**Re: Opposition to Proposed WADC Wastewater Discharge to Lick Creek**

The WADC recently submitted a National Pollutant Discharge Elimination System ("NPDES") application to the TDEC Division of Water Resources ("DWR") for a new discharge of treated sewage wastewater to Lick Creek near Mile 10.3 in Hickman County. Along with the permit application materials, WADC submitted their Preliminary Engineering Report ("PER"), our review of which guides the basis for the following analysis of why TDEC should deny WADC's request for a permit.<sup>1</sup>

**Figure 4. Jones Creek WWTP and White Bluff WWTP Locations, Receiving Streams, and *E. coli* Data Proposed WADC Wastewater Systems Expansion Dickson County, Tennessee**

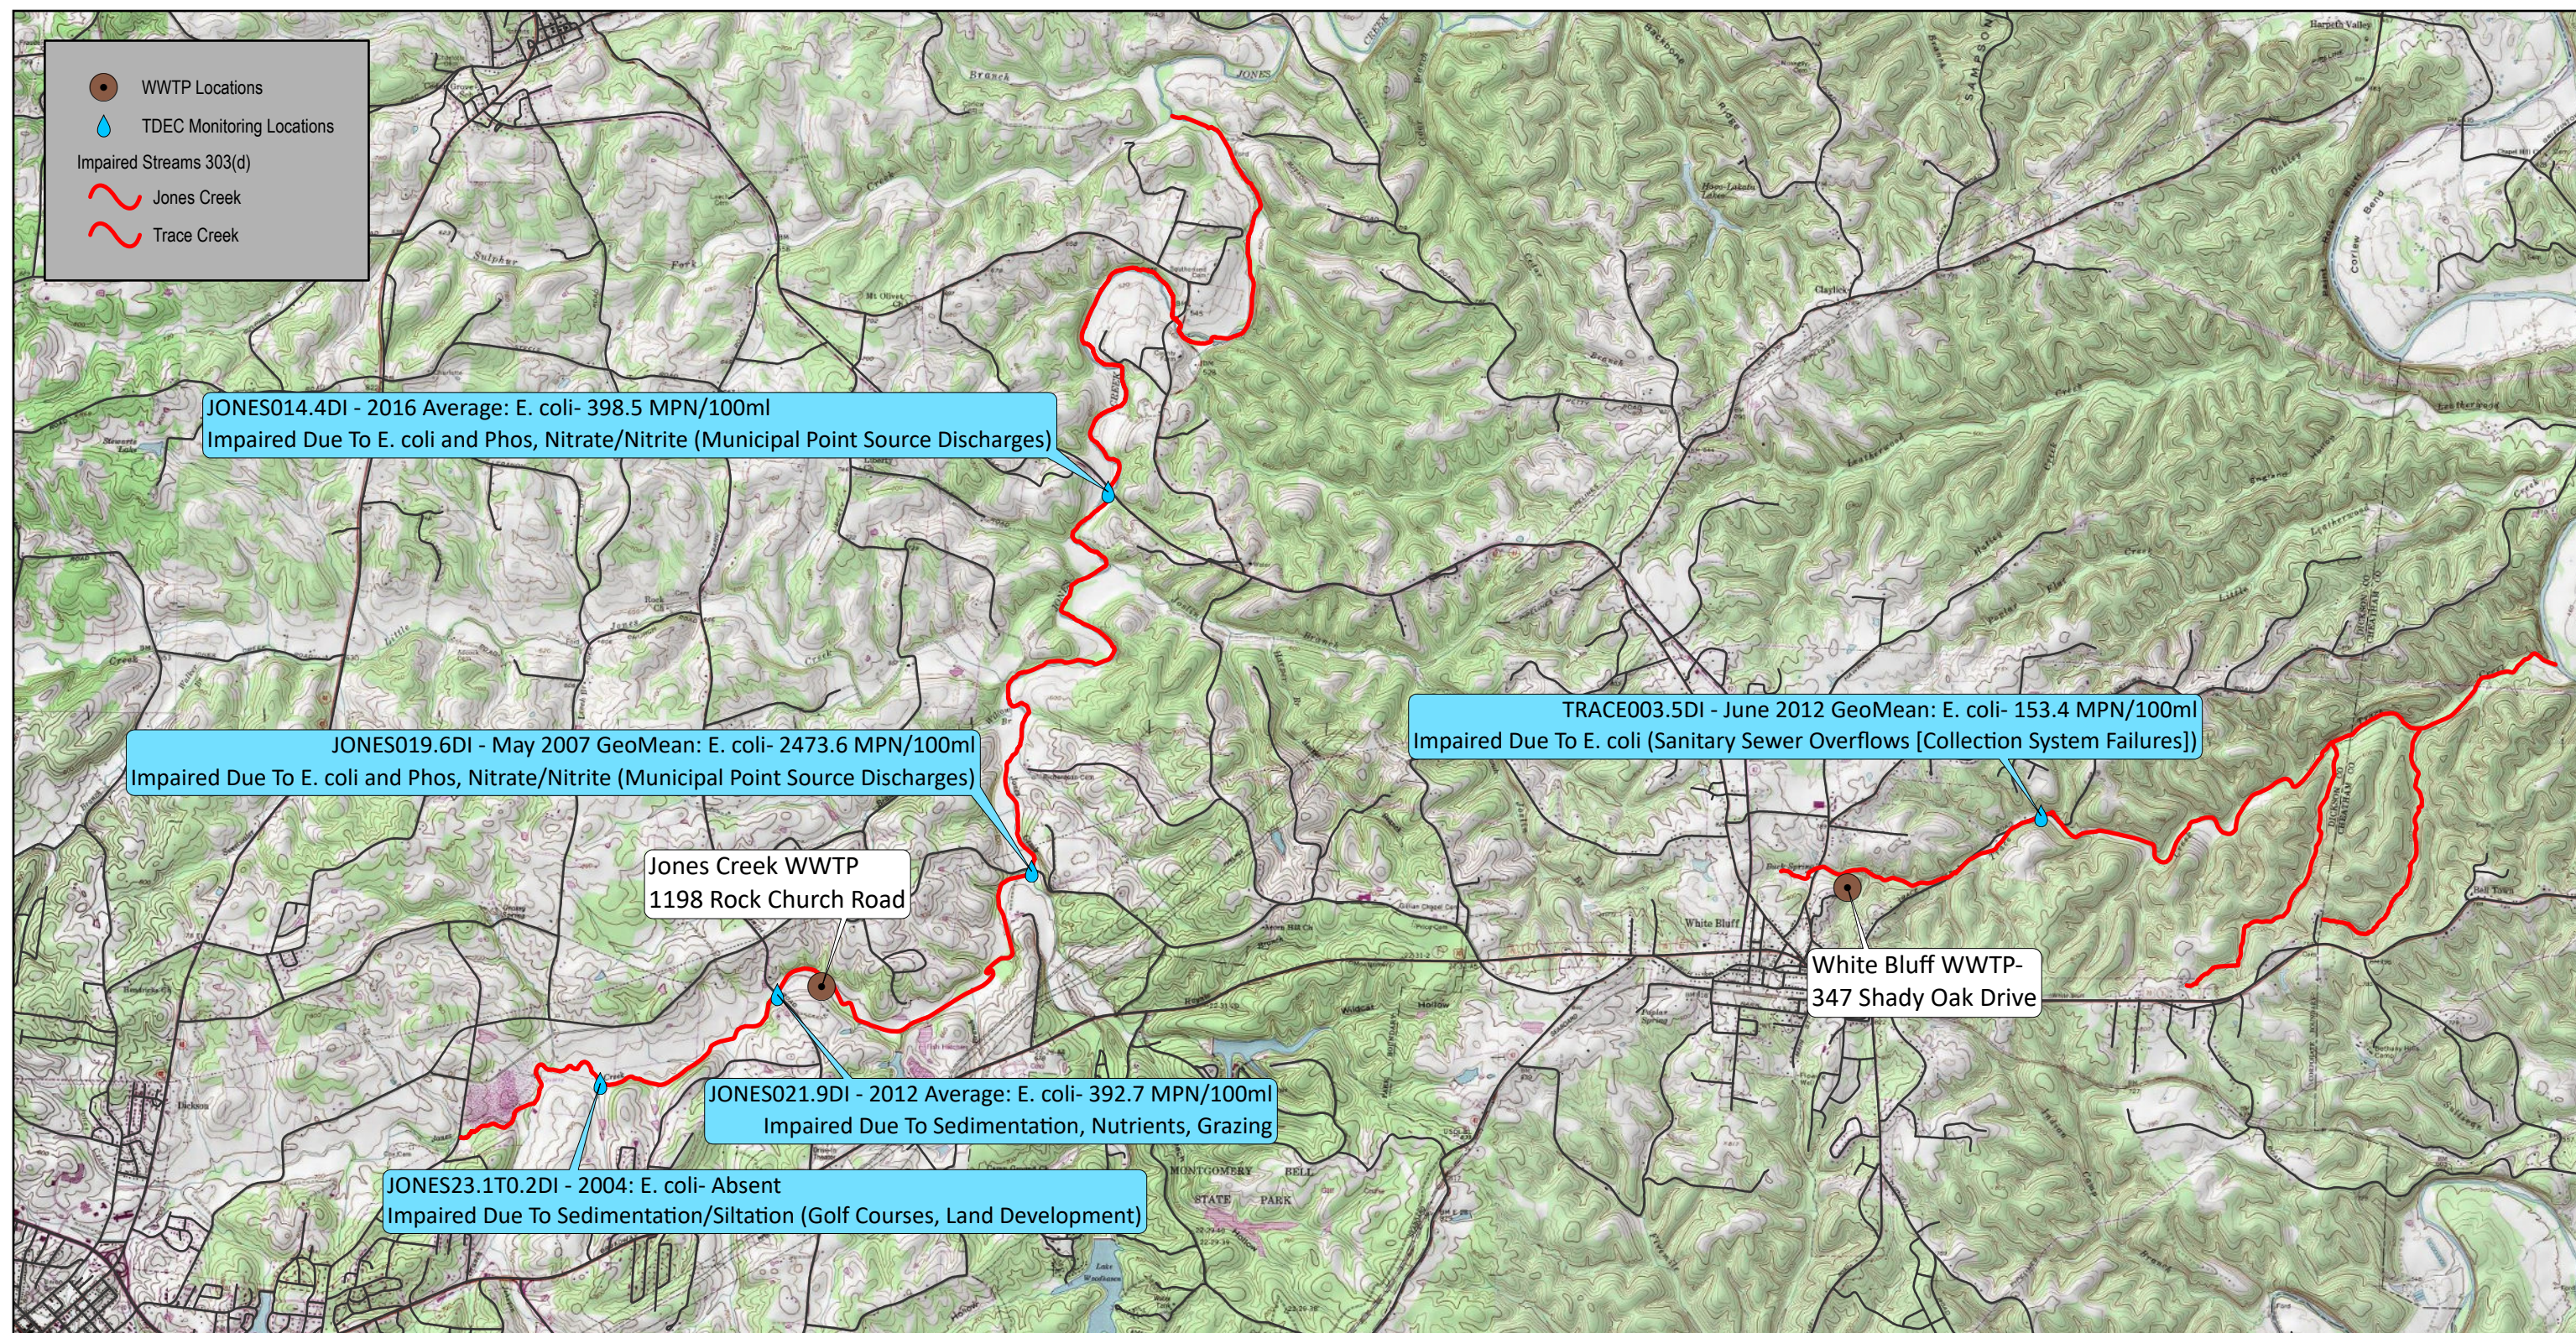
Further, TDEC monitoring data include *E. coli* water quality exceedances downstream of two of WADC's existing effluent discharges (Jones Creek and Trace Creek) (**Figure 4**). TDEC monitoring data are not available from Flatrock Branch, to which WADC discharges from its Fairview WWTP, but we note that a moratorium previously has been imposed on additional sewage connections because of chronic system overflows that likely affected Flatrock Branch.

Currently, WADC operates three wastewater treatment plants ("WWTPs") that serve portions of Dickson and Williamson Counties, and which respectively discharge to Jones Creek, Trace Creek, and Flatrock Branch, all of which are tributaries to the Cumberland River (**Figure 4**). Each of these plants is approaching its design capacity and all of them discharge to small, effluent-dominated tributaries to the Harpeth River.
